Project	IEEE 802.16 Broadband Wireless Access Working Group < http://ieee802.org/16 >	
Title	Sleep Mode Generic Mechanism	
Date Submitted	4-Nov-04	
Source(s)	<p>Vladimir Yanover Alvarion Ltd. 21 A Habarzel St. Ramat - Hahayal Tel - Aviv 69710 P.O. Box 13139, Tel-Aviv 61131, Israel</p> <p>Yigal Eliaspur, Ben-Porath Sharon, Rosner Gedon, Efraim Sagi Penny. Intel Corp.</p>	<p>Voice:+972-36457834 Fax: +972-36456222 mailto:vladimir.yanover@alvarion.com</p> <p>Voice:+972-547884877 mailto:yigal.eliaspur@intel.com</p>
Re:	The document supports a comment at Sponsor Ballot on 802.16e/D5 document	
Abstract	The documents suggests text changes to incorporate different cases of Sleep Mode operations into a single scheme	
Purpose	The document is for consideration during Sponsor Ballot comments resolution	
Notice	This document has been prepared to assist IEEE 802.16. It is offered as a basis for discussion and is not binding on the contributing individual(s) or organization(s). The material in this document is subject to change in form and content after further study. The contributor(s) reserve(s) the right to add, amend or withdraw material contained herein.

Sleep Mode Generic Mechanism

3. Spec

Power Saving Class for multicast connection

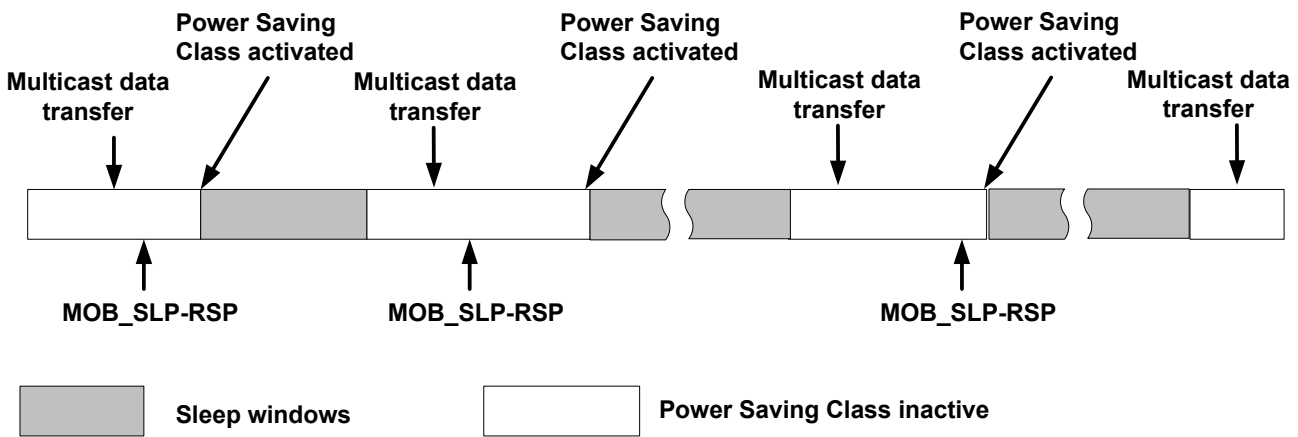
The following picture illustrates suggested Sleep implementation for multicast connection. The corresponding Power Saving Class is associated with the corresponding multicast connection. When activated (by MOB_SLP-RSP from BS), the class of this type provides a single sleep window. After expiration of sleep window, the MSS is awake and if multicast data is already available, it may be transferred, otherwise Power Saving Class is re-activated and the MSS enters sleep window.

Power Saving Class Usage for Periodic Ranging

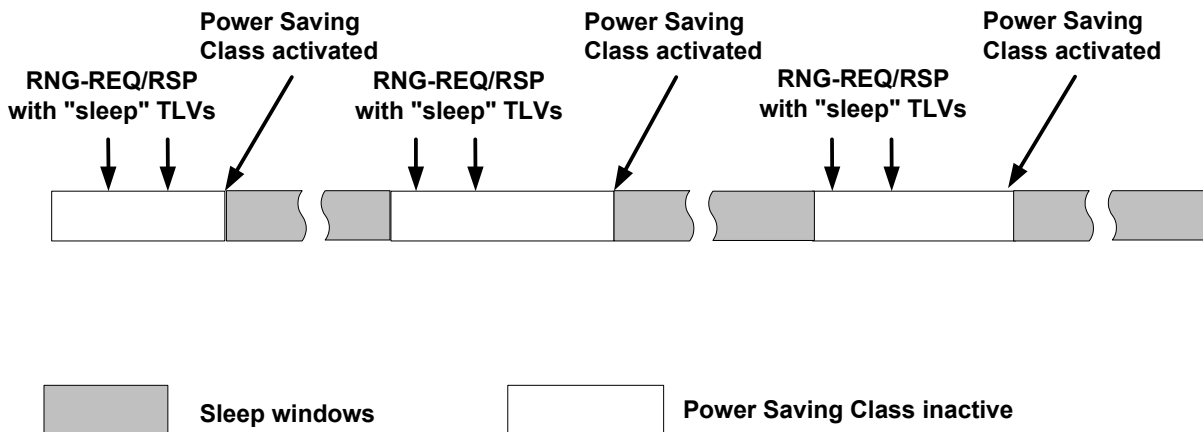
Next picture describes suggested Sleep implementation for Periodic Ranging procedure. The corresponding Power Saving Class is associated with Basic connection of the MSS. At initial point MSS and BS perform Periodic Ranging transaction using RNG-REQ/RSP messages that contain TLVs to configure and activate Power Saving Class of same type as for multicast connections. A listening window of this class is used again for exchange of RNG-REQ/RSP messages, which again may activate Power Saving Class etc.

Figure NNN. Example of Sleep Mode Operations with two Power Saving Classes

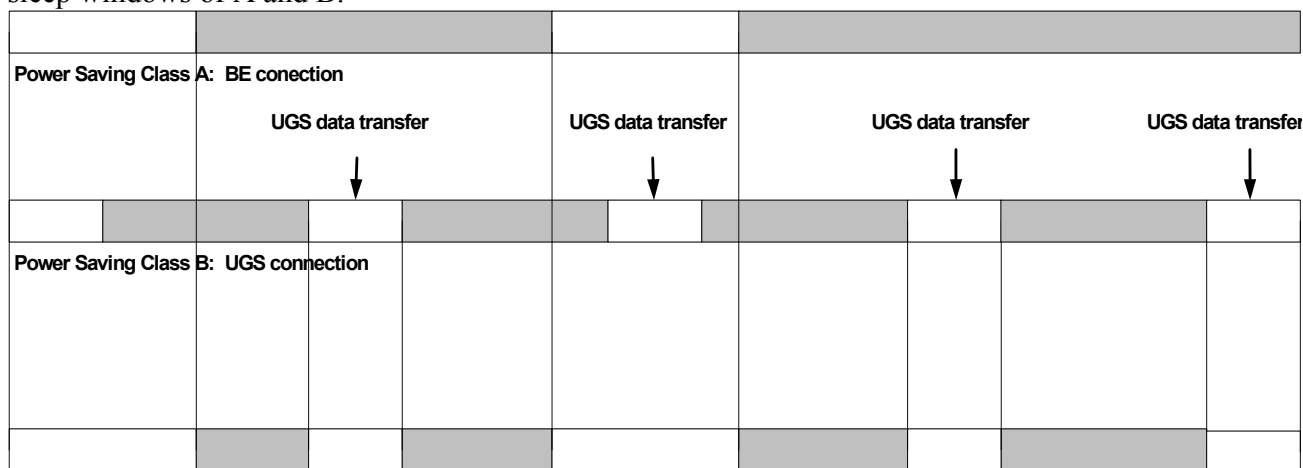
Figure NNN describes example of behavior of MSS with two Power Saving Classes: Class A contains several connections of BE and NRT-VR type, Class B contains a single connection of UGS type. Then for Class A the BS allocates sequence of listening window of constant size and doubling sleep window. For Class B the BS allocates sequence of listening window of constant size and sleep window of constant size. The MSS is considered unavailable (and may power down) within windows of unavailability, which are intersections of sleep windows of A and B.
